**PLANNING BOARD
PORTSMOUTH, NEW HAMPSHIRE**

April 20, 2023

To: Planning Board
From: Peter Stith, Planning Manager
Date: April 20, 2023
Re: Recommendations for the April 20, 2023 Planning Board Meeting

C-103

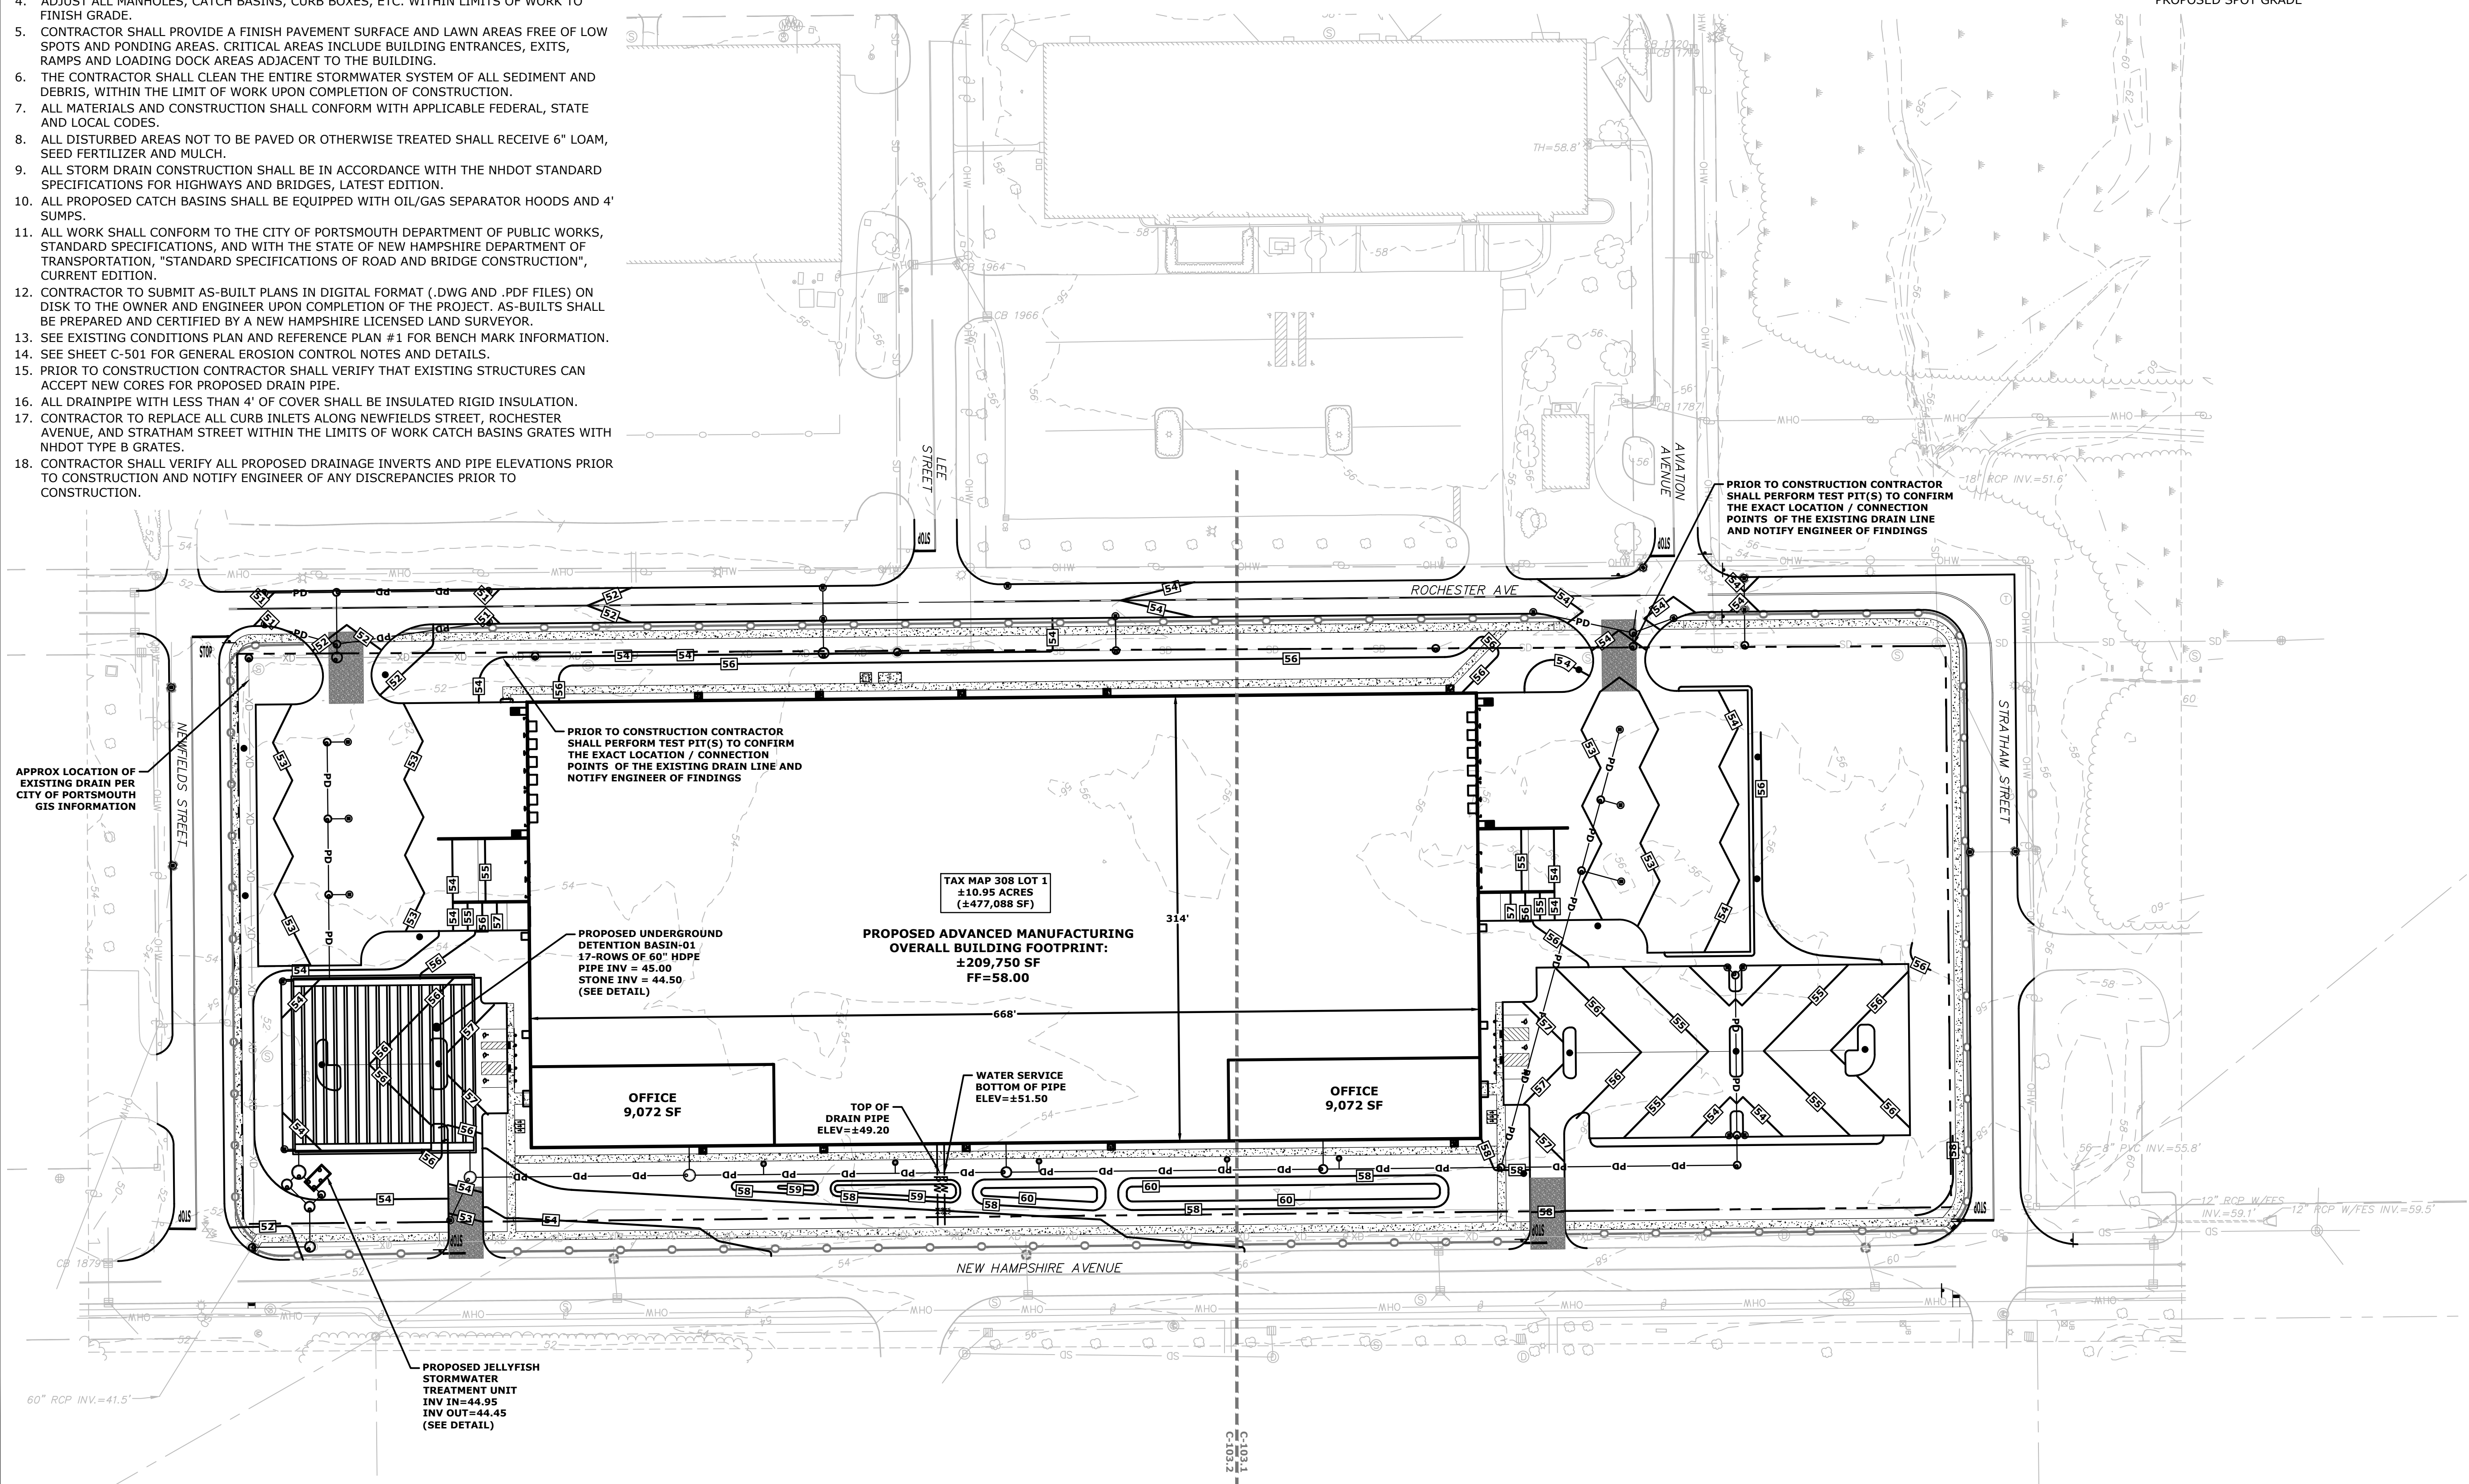
Note #16 was added to Sheet C-103 stating, "All drainpipe with less than 4' of cover shall be insulated with rigid insulation."

The legend on Sheet C-103 has been revised to include the 'XD' linetype as the approximate location of existing drain per city of Portsmouth GIS information.

Notes were added to Sheet C-103 stating, "Prior to construction contractor shall perform test pit(s) to confirm the exact location / connection points of the existing drain line and notify engineer of findings".

The proposed water service connections and the approximate pipe elevations have been added to Sheet C-103. The proposed design should provide approximately 2.3' of separation between the proposed drain line and the proposed water services.

100 NEW HAMPSHIRE AVENUE PORTSMOUTH, NH	
ARRIVAL & DEPARTURE TRIP DISTRIBUTION - TRUCKS	
DATE: 02/16/2023	
SCALE: NTS	
FIGURE 6

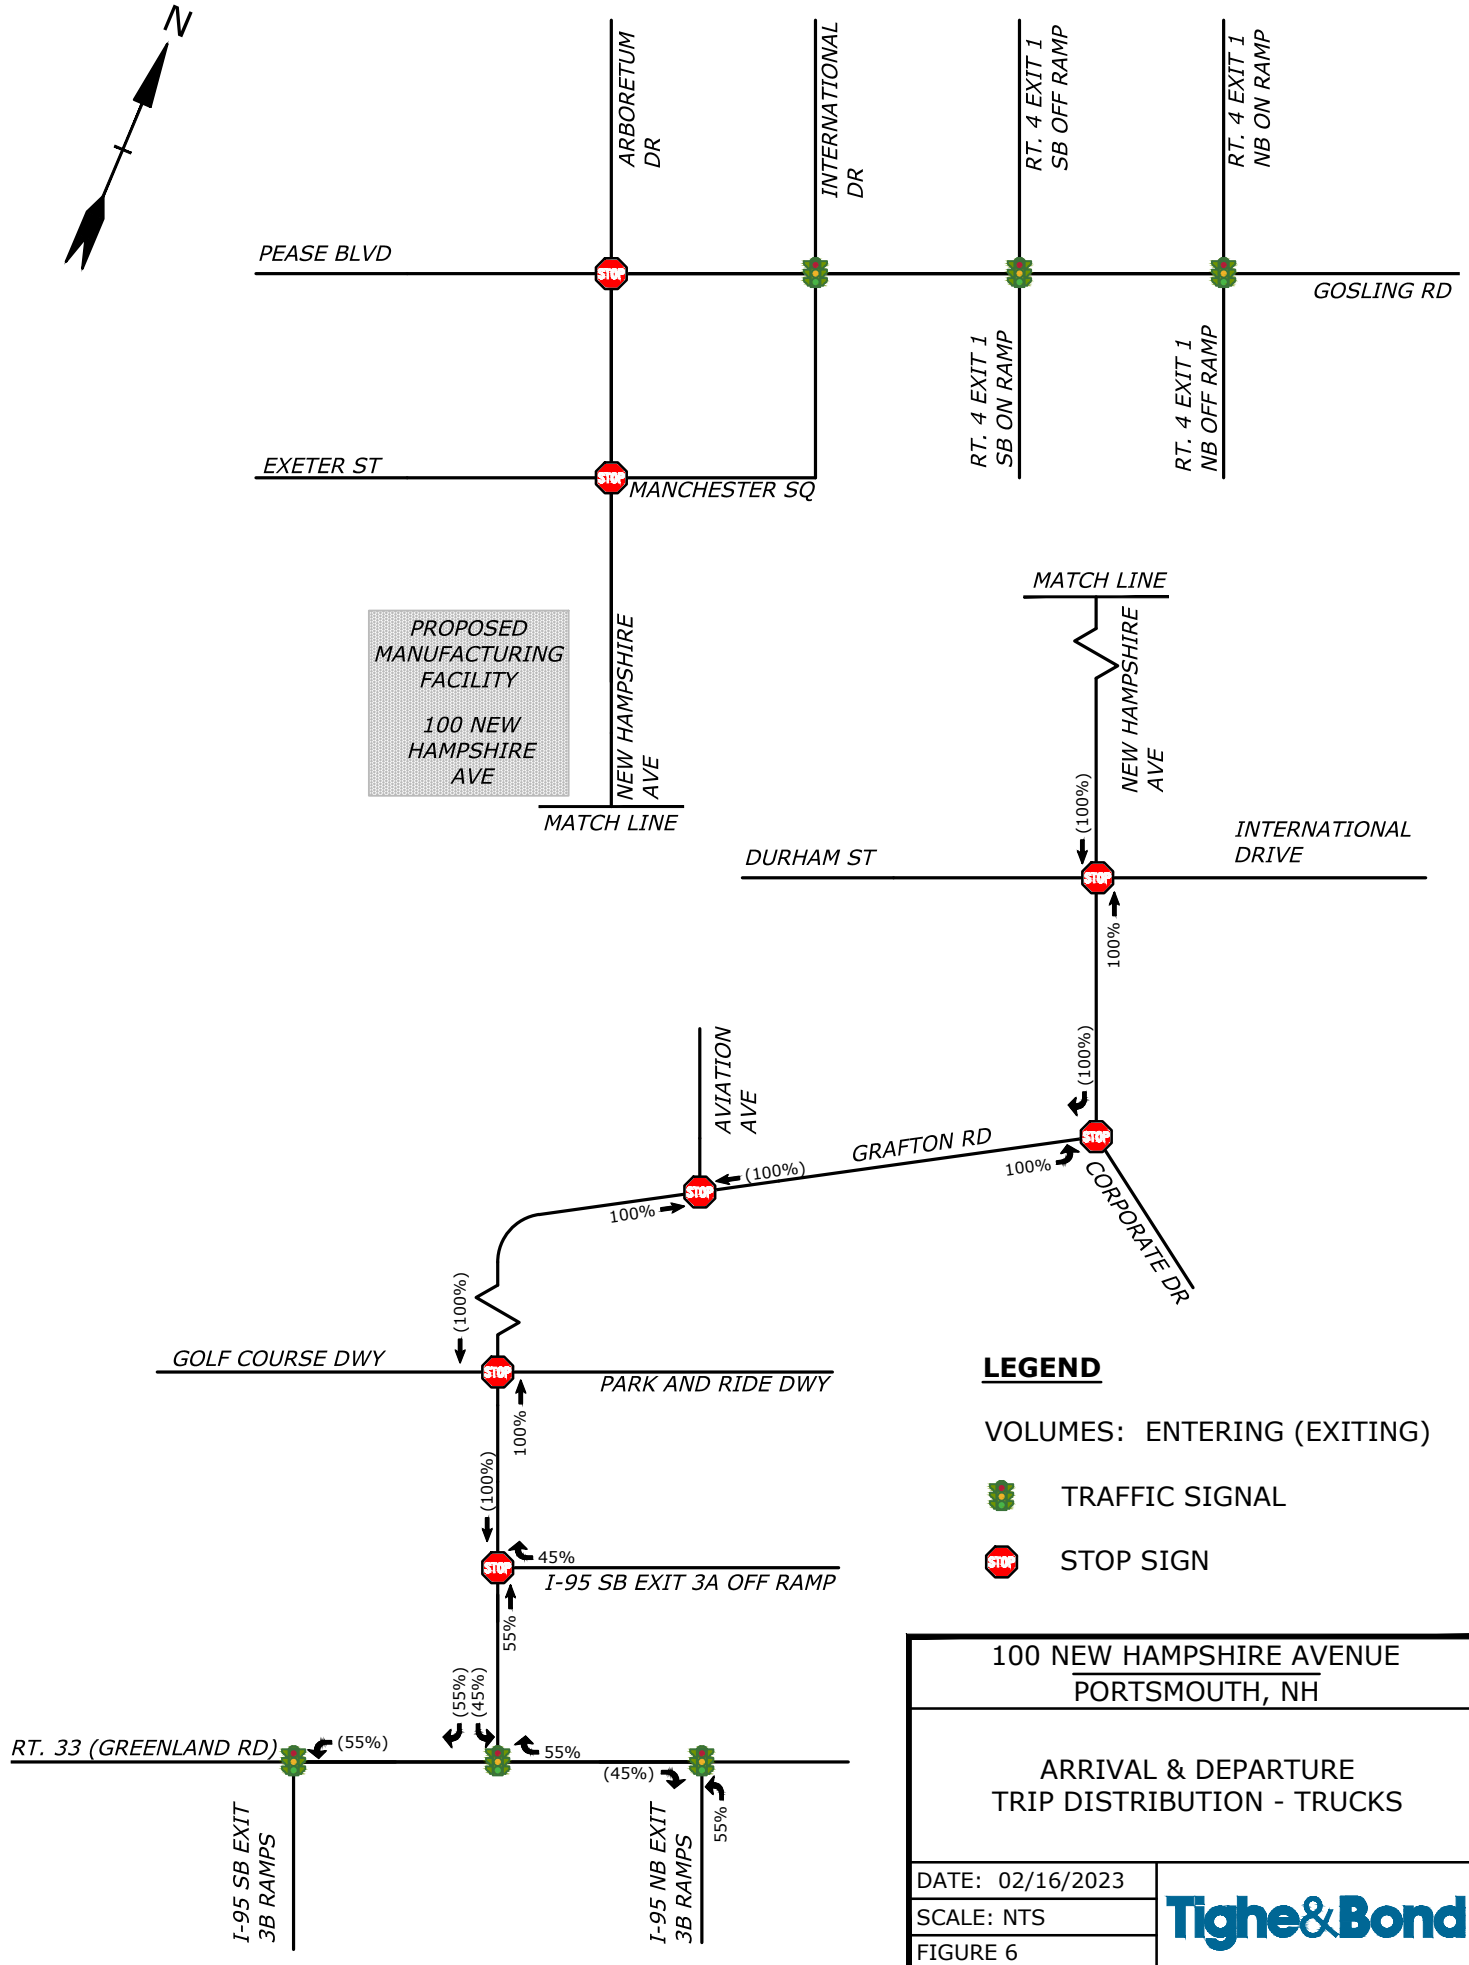
Supplemental Comment: As presented in the original and revised traffic studies, adequate sightlines are not provided at the Rochester Avenue site driveway to the north due to the horizontal curvature of the Rochester Avenue and Stratham Street junction. Figure 6 shows the overall truck traffic being distributed to the south but does not show the distribution of trucks on Rochester Avenue. **Therefore, there should be a commitment to not allow trucks through this junction.**

Tighe & Bond Response: Trucks are not expected to travel through this intersection, with all truck traffic distributed to the south as shown in Figure 6 of the TIA.

Response: Trucks are not expected to travel through this connection, with all truck traffic distributed to the south as shown in Figure 6 of the TIA.
